NATIONAL INTERAGENCY FIRE CENTER

National Fire Equipment System Cache Memorandum No. 04-3

Subject: Cargo Swivel Retrofit Project

Old Style Spring Hooks

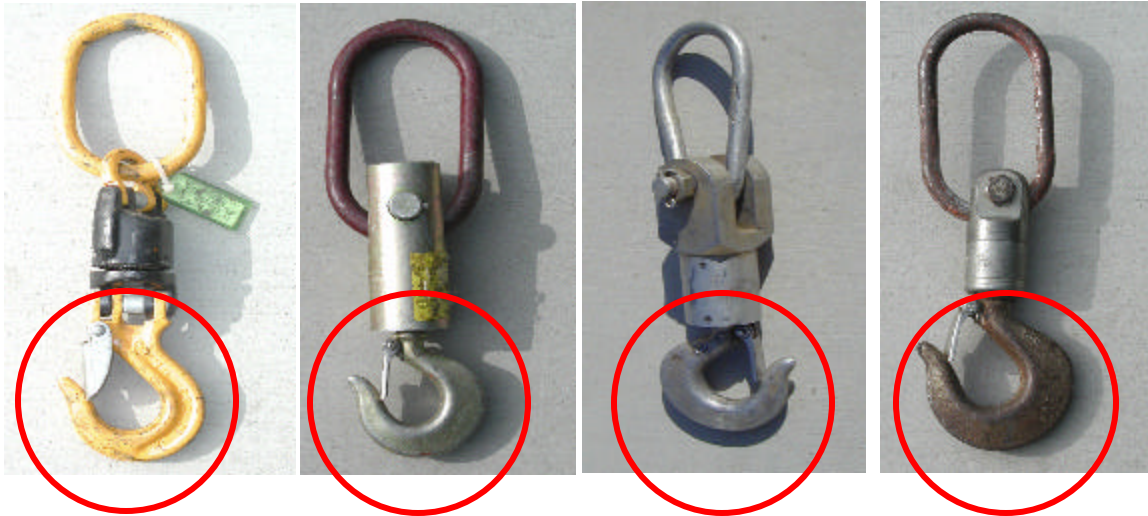
Recent quality control complaints have identified failures of the spring gates on old style (pre-1992 models) 3000 lb cargo swivels (NFES #0526) resulting in the inadvertent release of several sling loads during fire suppression operations. These complaints prompted a review of the various cargo swivel designs currently in use in order to resolve these concerns.

In the early 1990's, the San Dimas Technology and Development Center (SDTDC) evaluated and subsequently recommended a change in the hook design installed on the 3000 lb cargo swivel hook. The typical old style design included a hook with a spring returning gate (see figure 1). Other variations of the old style design can be seen in Attachment 1. The new design uses the gate as part of the load-suspending system through a hinge with the hook part, see figure 2. The improved hook was added to the cargo swivel and the cargo swivel hook assembly has been procured in this configuration since that time.

The first line item is the retrofit of the hook from the spring gate hook to the self-closing under load style hook that has been procured over the last 10 years.

The second line item is replacement of the link. This is not normally expected to be done, but if the swivel's link is under sized or in unacceptable shape it will be replaced.

The third item is the replacement of the link attachment device. Some swivels in the past have been delivered with cotter pins and other "safety" devices that provide sharp points or catch hazards. These attachments will be replaced with better fastener systems.

In order to maximize the investment in the older swivels and to take advantage of their inherent durability, the possibility of retrofitting older swivels with the new load closing hooks was investigated. These efforts were successful and have resulted in the establishment of a four-year contract for the retrofit of the old hooks to the newer load closing hook design. Although there are several variations and differing manufacturers of the older spring gate sling swivel, the hook retrofit is compatible with all known patterns of the spring gate design. Retrofitted swivels will be in an “as new” condition in regard to expected service life and function.
